**CITY OF CROSSLAKE
PLANNING COMMISSION/BOARD OF ADJUSTMENT
September 24, 2021**

PUBLIC HEARING NOTICE

Site Location: 33591 Lake Street, Crosslake, MN 56442 on Crosslake-GD

STAFF REPORT

CERTIFICATE OF SURVEY

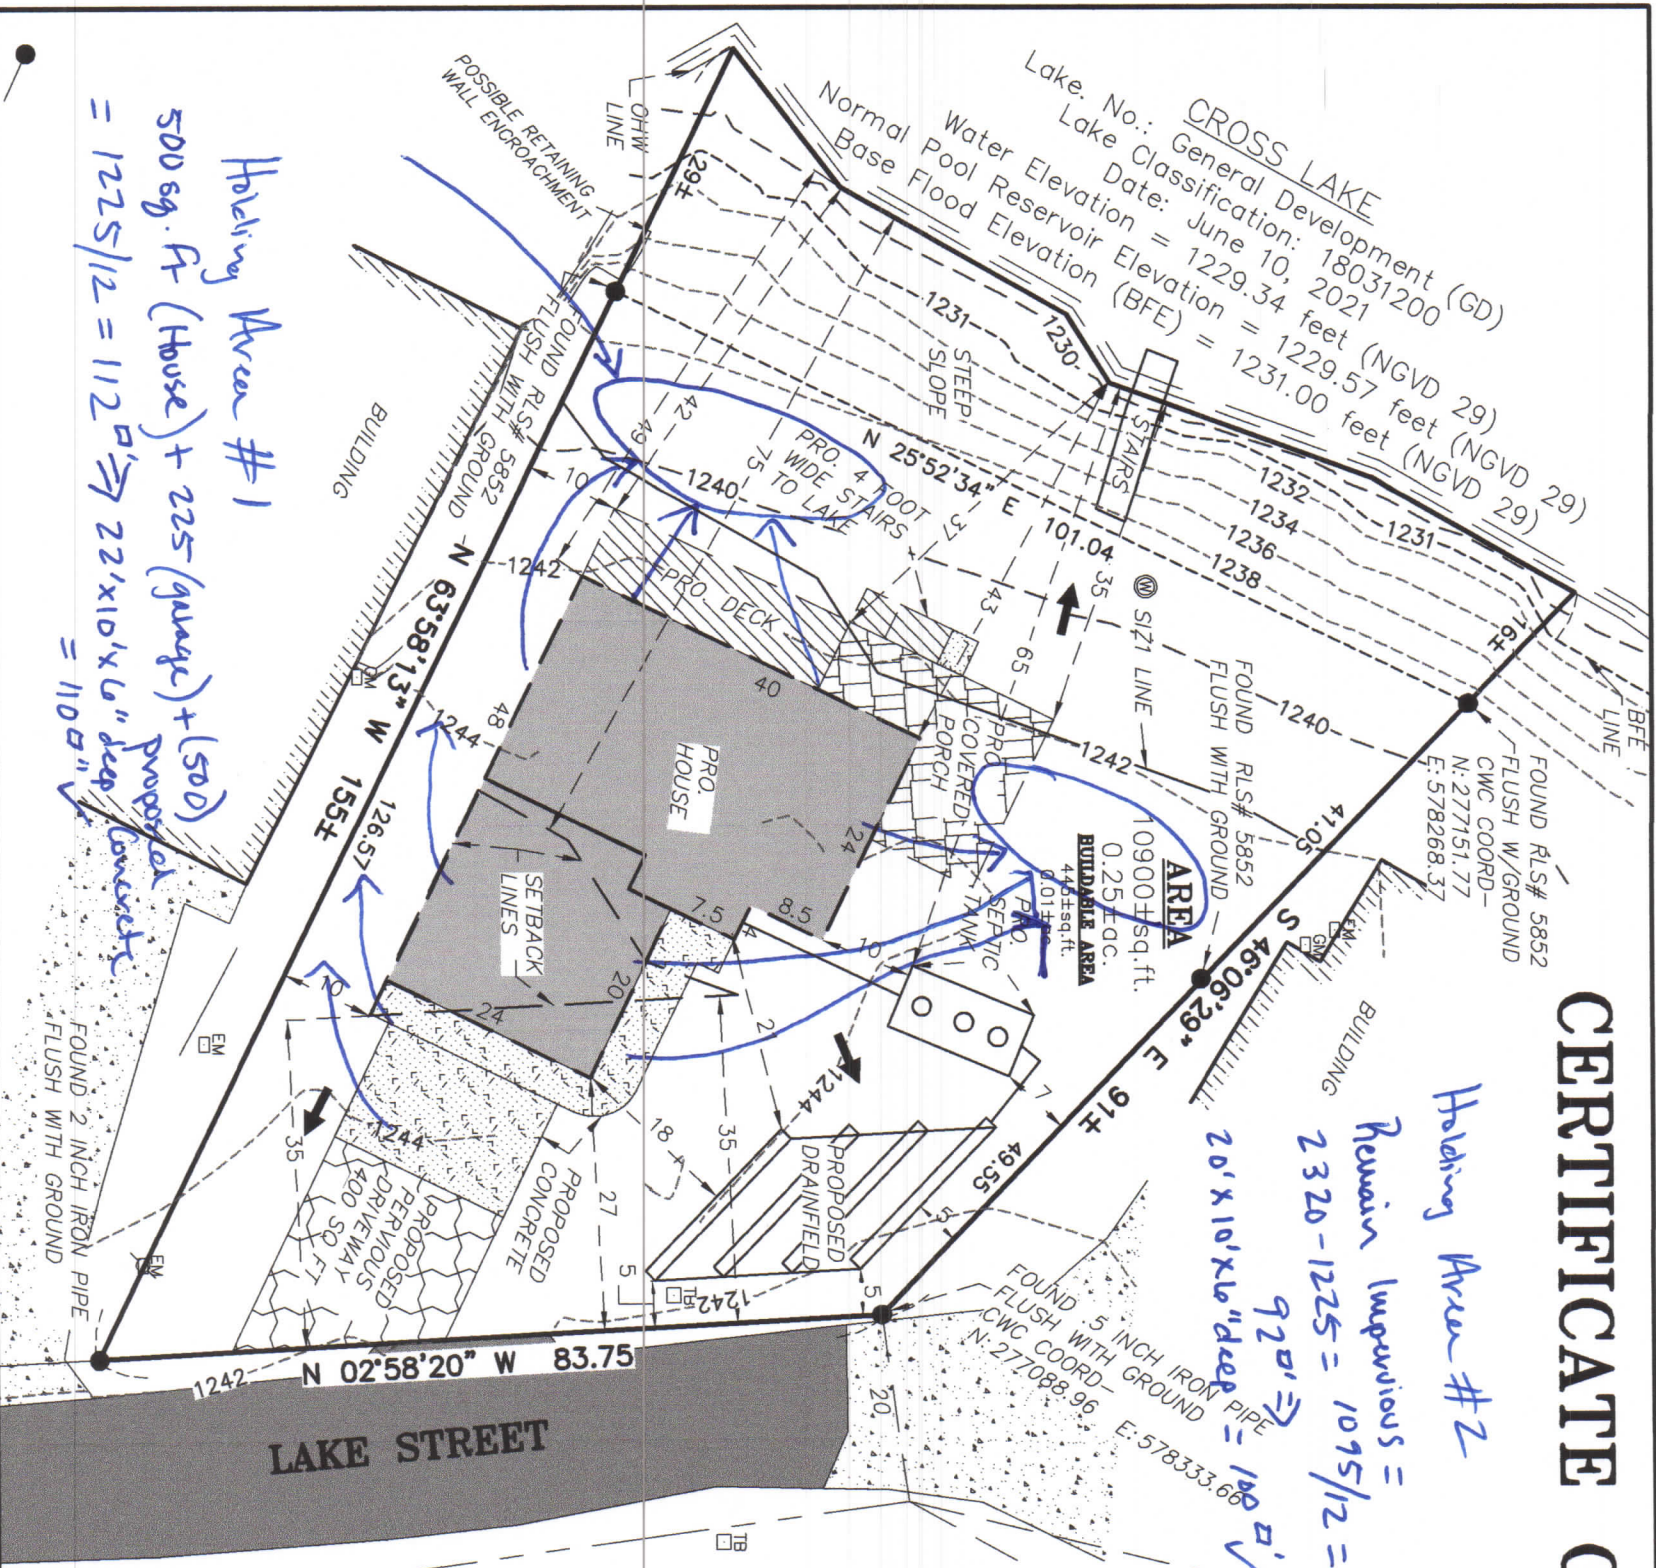
- Property is located on Crosslake at 33591 Lake Street with a lake setback of 75 feet
- The proposed demo/replace to be no closer/approximately 34 feet from the OHW of Crosslake
- Staff inquired as to why not move the garage road ward since more sq feet is being requested along the lake than the existing demo cabin (covered deck)
- Pervious pavers of 400 sf is allowed by installers specs and annual maintenance
- **Possible condition** to have spoil pile behind 75' setback or to be removed
- All setbacks shall be measured to the vertical side of the structure. No part of the structure, such as eaves, can overhang or reduce such setback by more than three feet (Sec. 26-308)

- If the eaves exceed 36" the setback and the impervious coverage shall be measured from the dripline
- Impervious maximum of 25% and if impervious exceeds 20% a Shoreline Rapid Assessment Model form will be completed (Sec. 26-518)

As shown on the certificate of survey dated 8-4-2021
